**BRADBURY PLACE TOWNHOMES**  
A PORTION OF SECTION 3, TOWNSHIP 19N, RANGE 04 E, W.M.  
CITY OF PUYALLUP, PIERCE COUNTY, WASHINGTON

SHEET TITLE: COVER SHEET AND HORIZONTAL CONTROL

PROJECT:	20-223
DWG NAME:	20-223 C
SHEET	REV.
C1	0
1 OF 28

**SHEET TITLE: 5TH ST SE PLAN AND PROFILE**

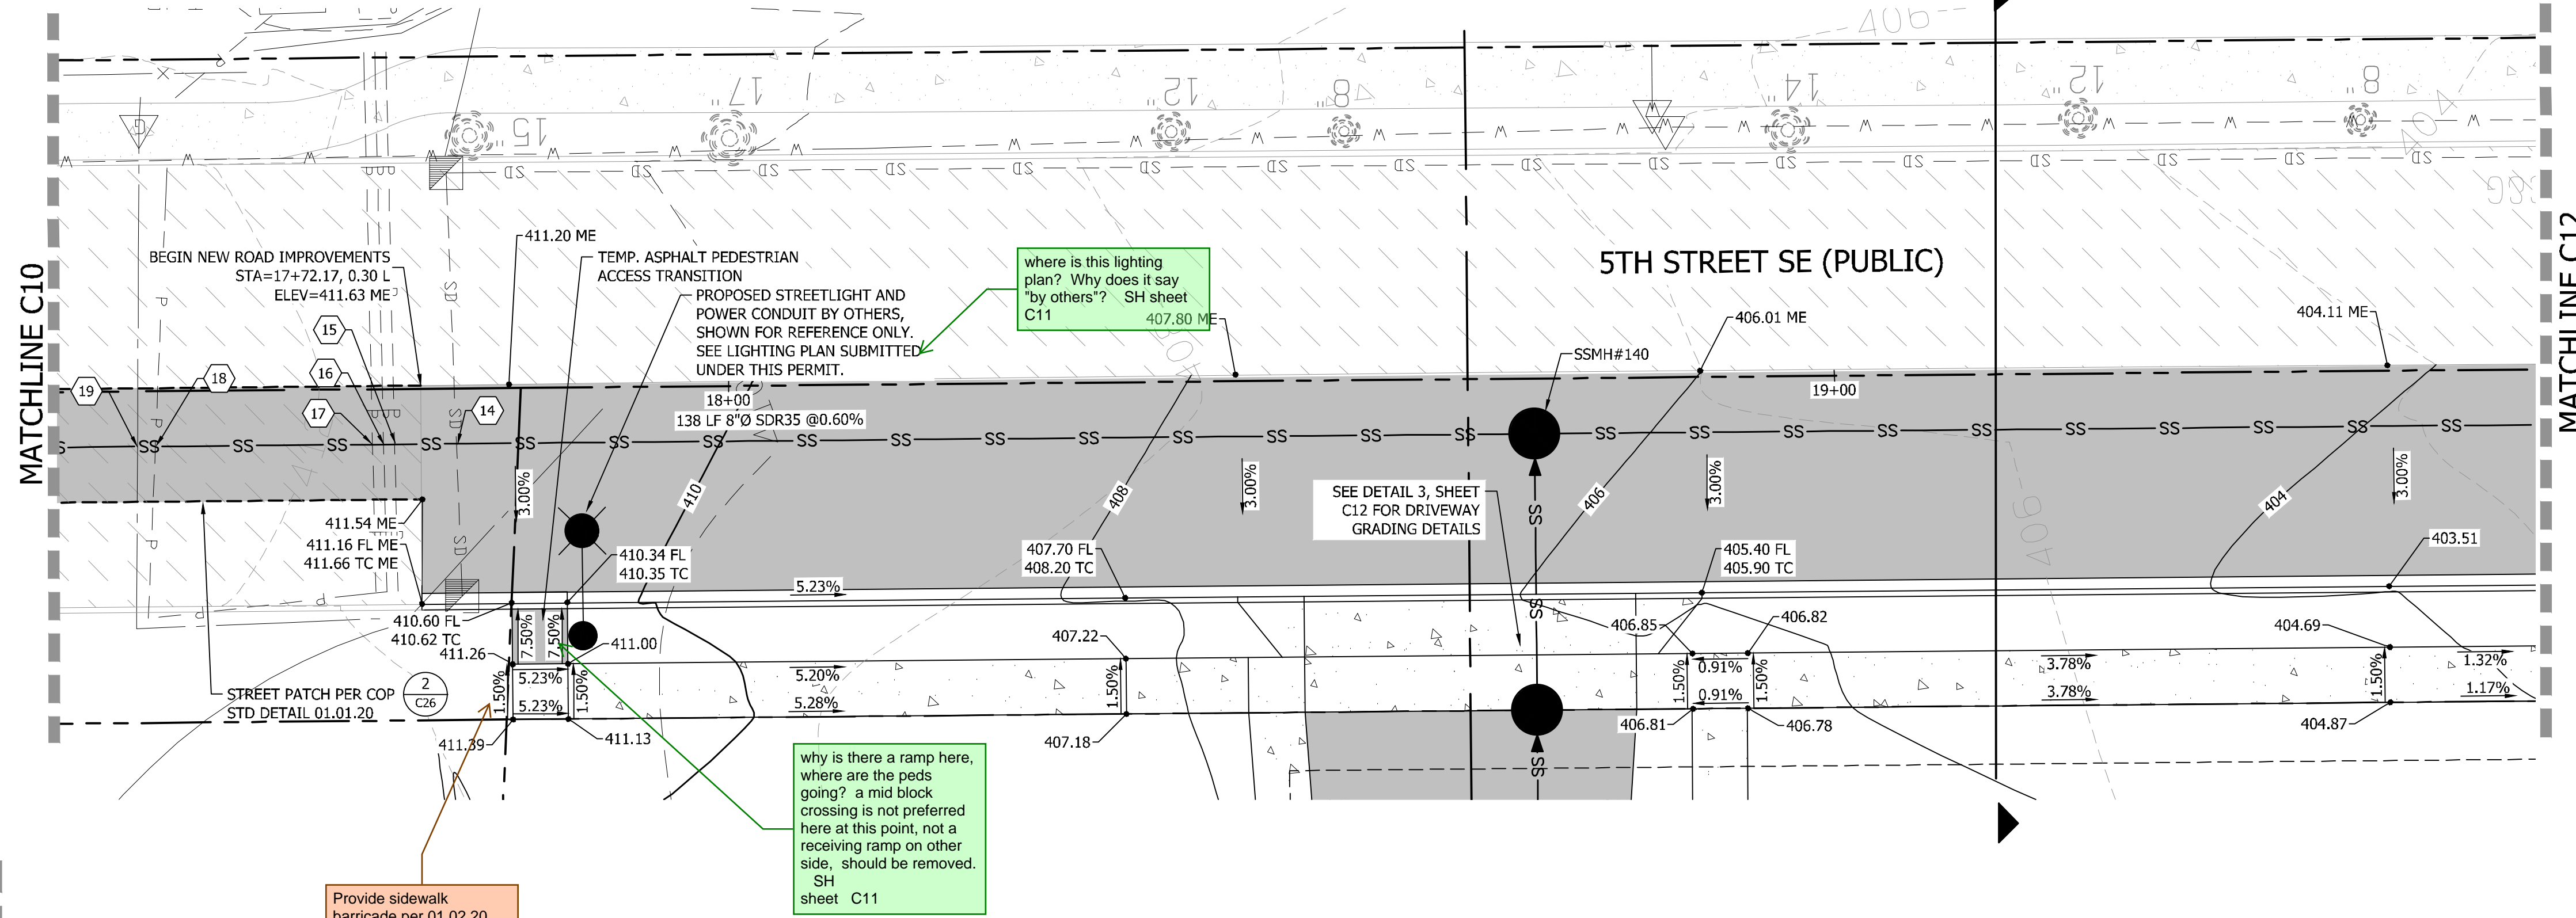
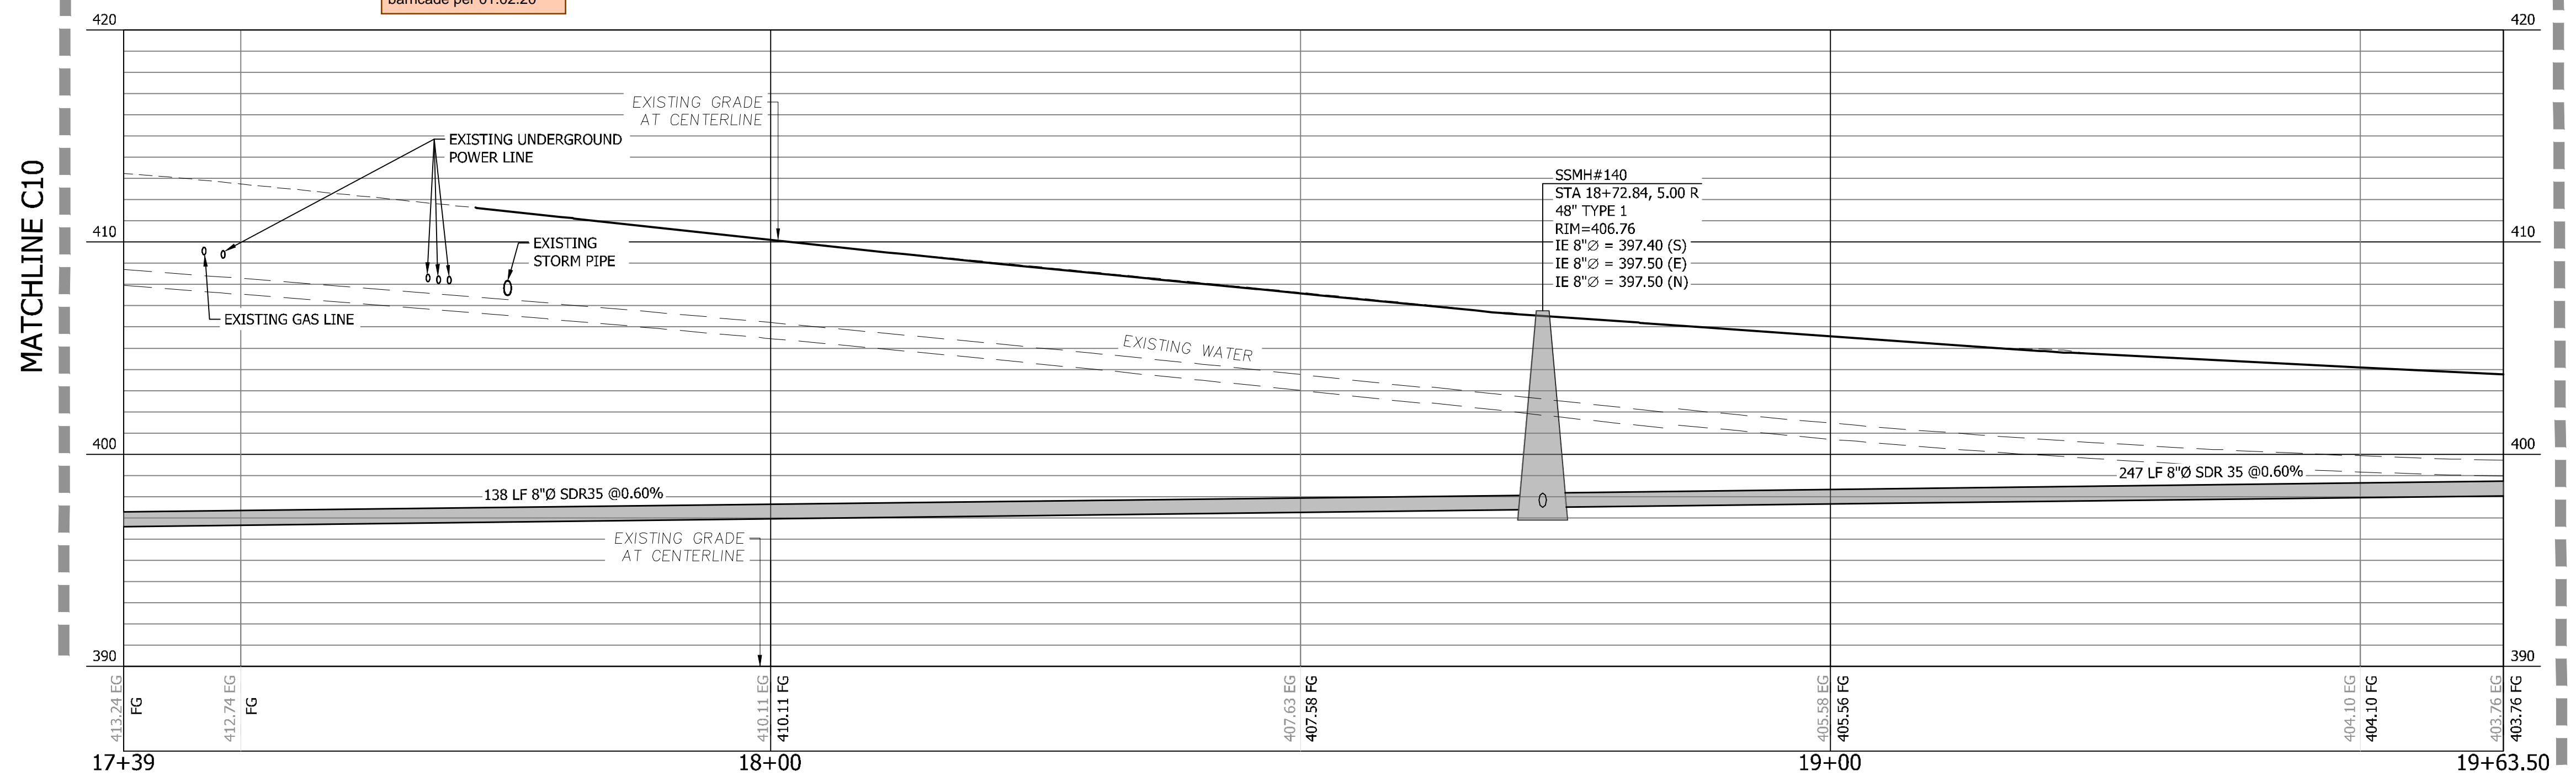
are there illumination plans? spare conduit required through entire project extents SH Sheet C11

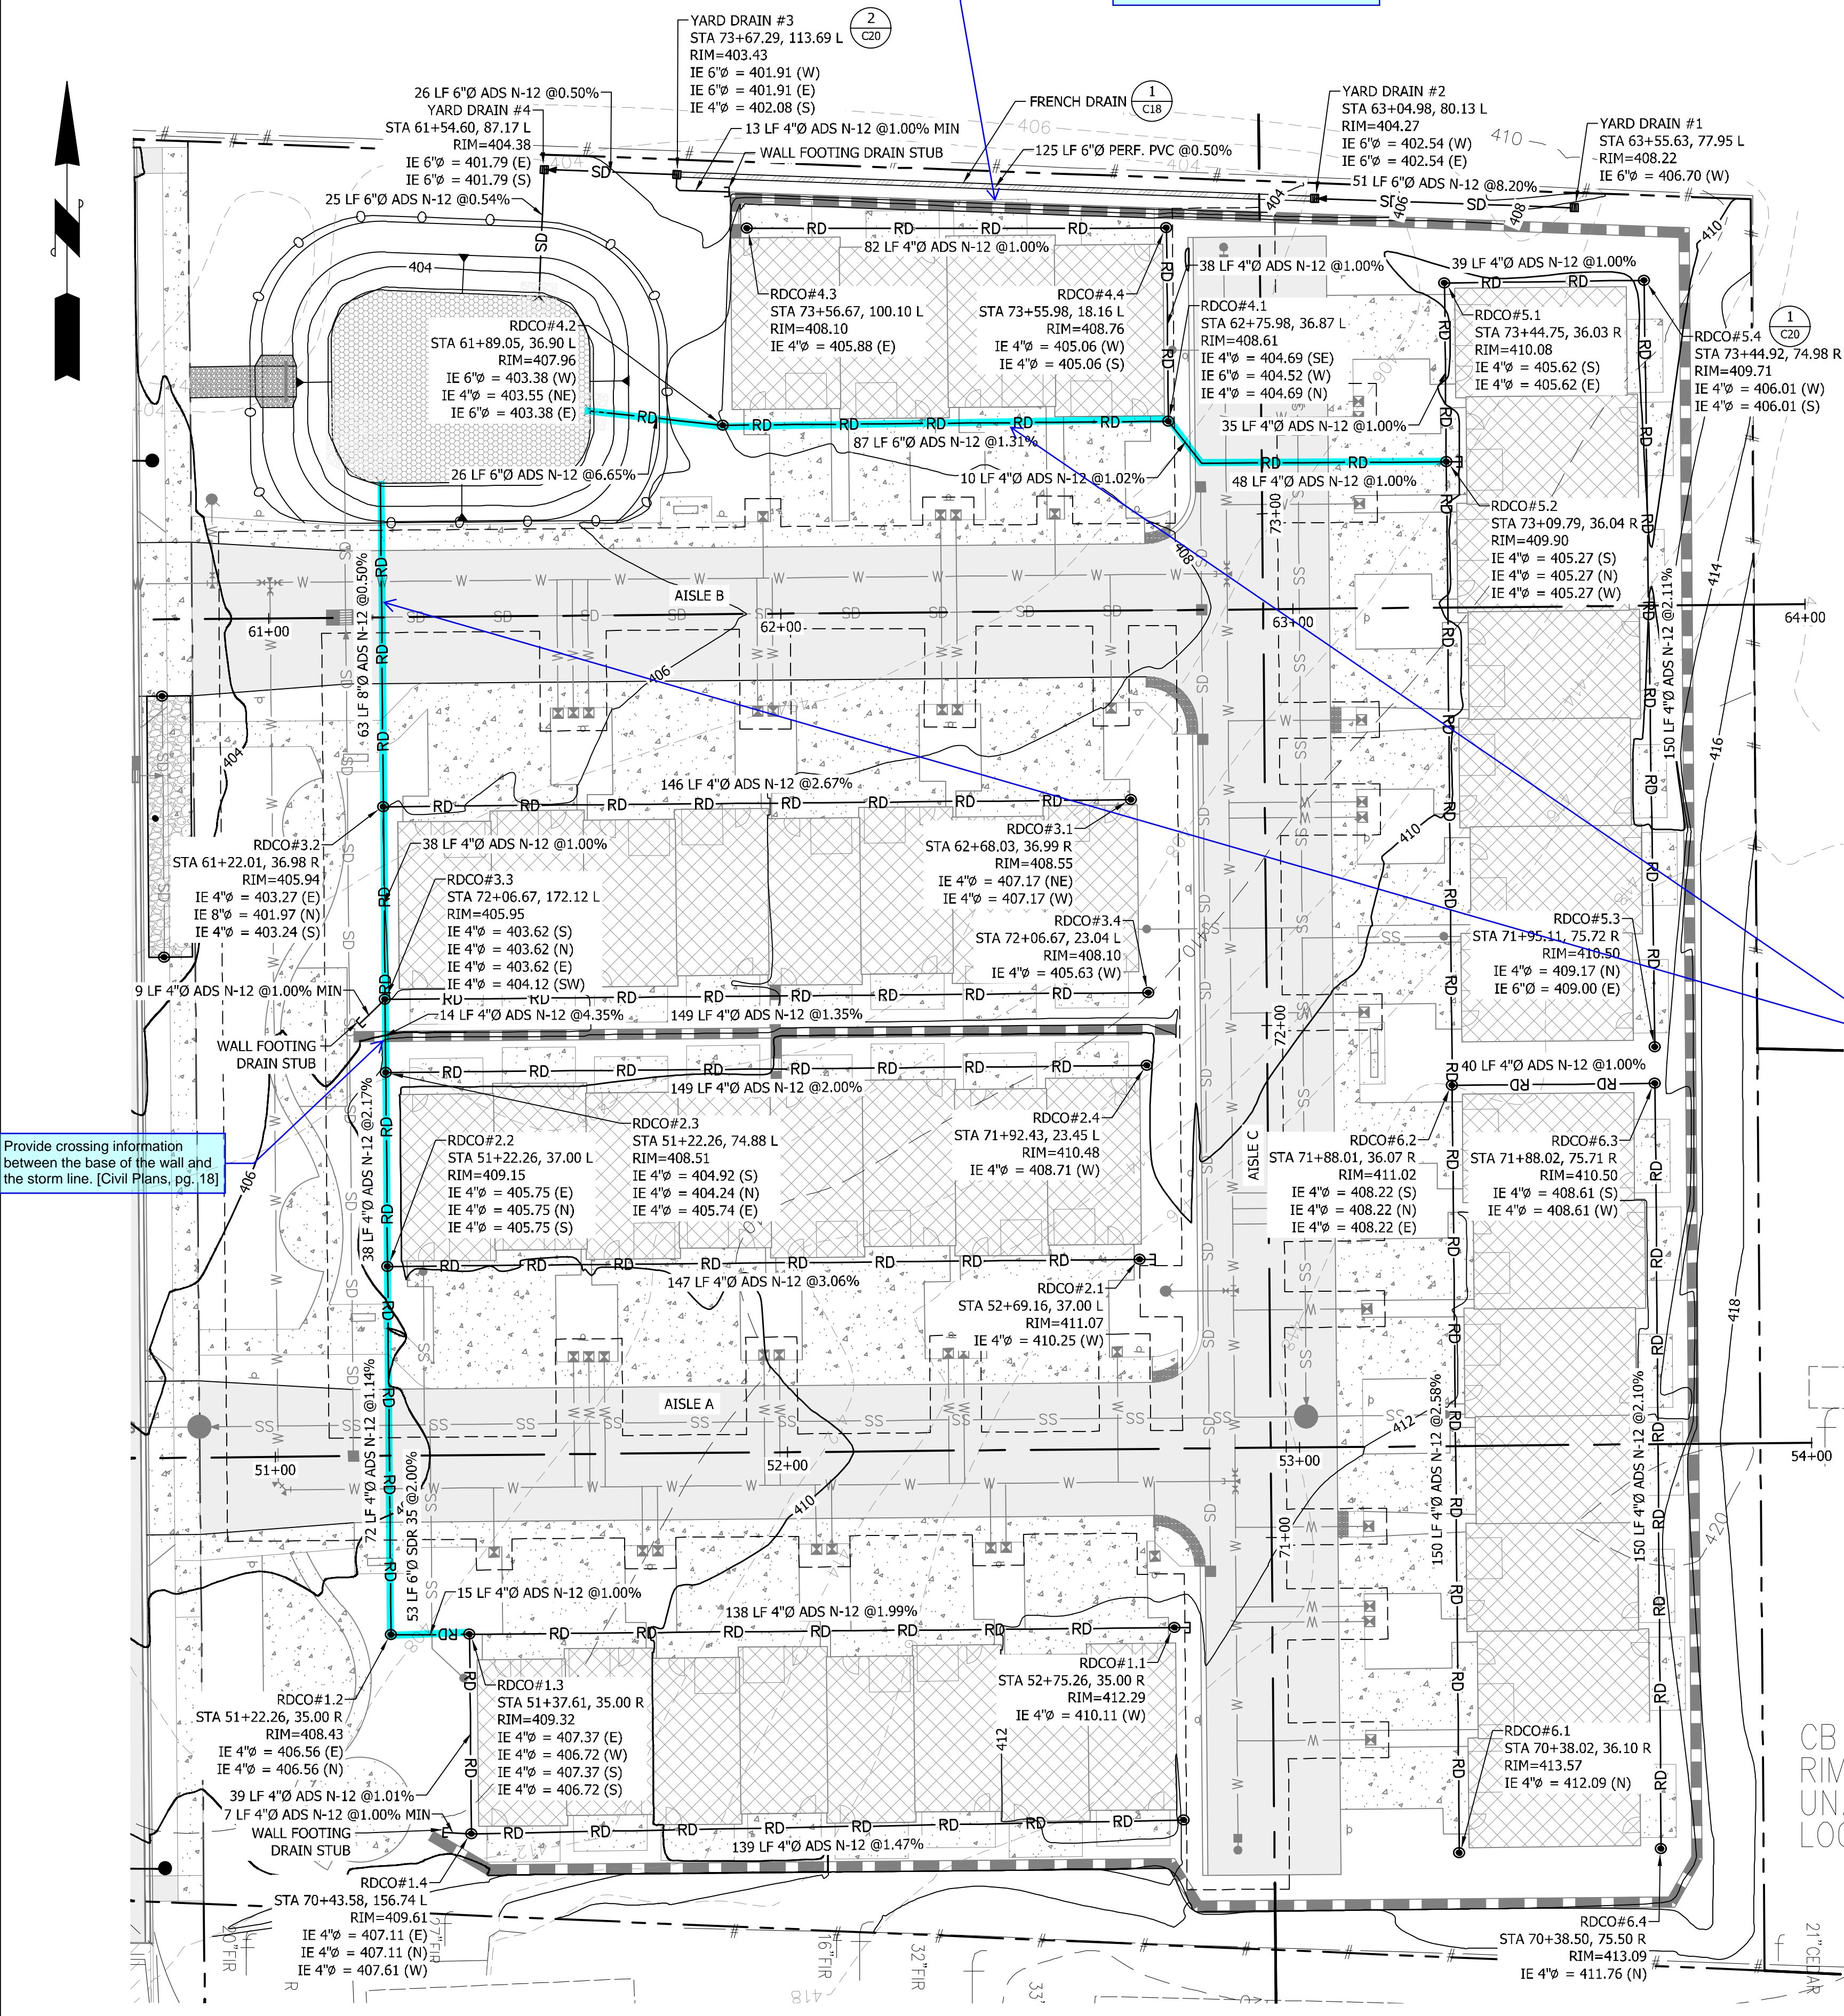
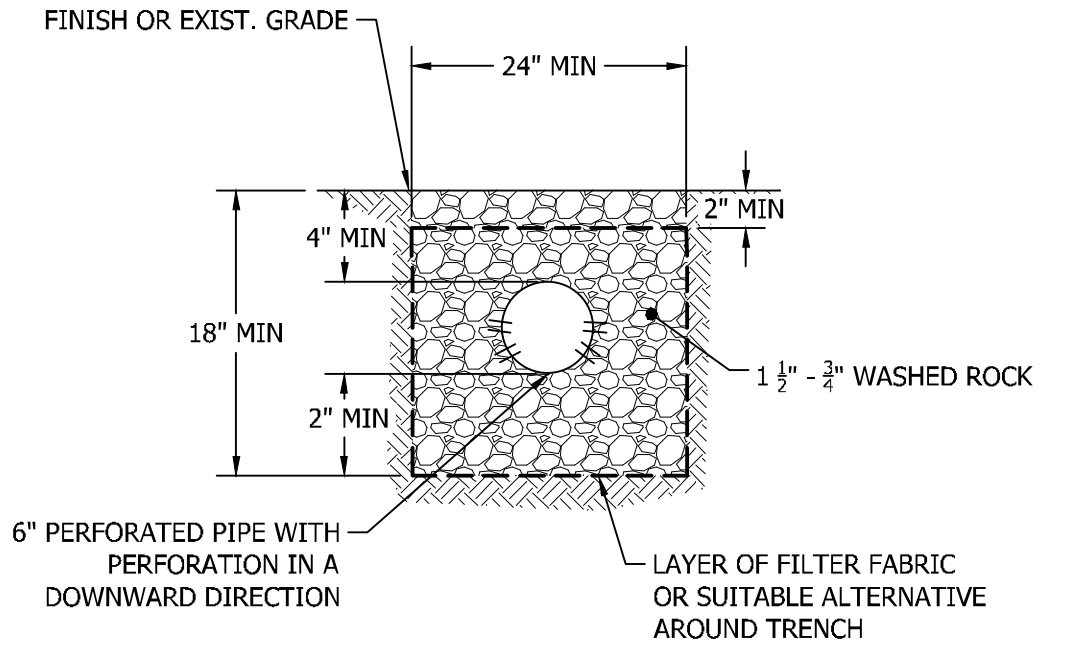
ADS N-12 is not an approved roof drain pipe material. Refer to section 204.4.7 of the City's Stormwater Standards for guidance on approved pipe materials. [Civil Plans, pg. 18]

The highlighted portions of pipe labeled as roof drain are conveying a significant amount of runoff. After the roof drains leave the building, they are considered to be laterals, and will need to be upsized to meet the City's standard for laterals. Refer to section 204.3 of the city's design standards. [Civil Plans, pg. 18]
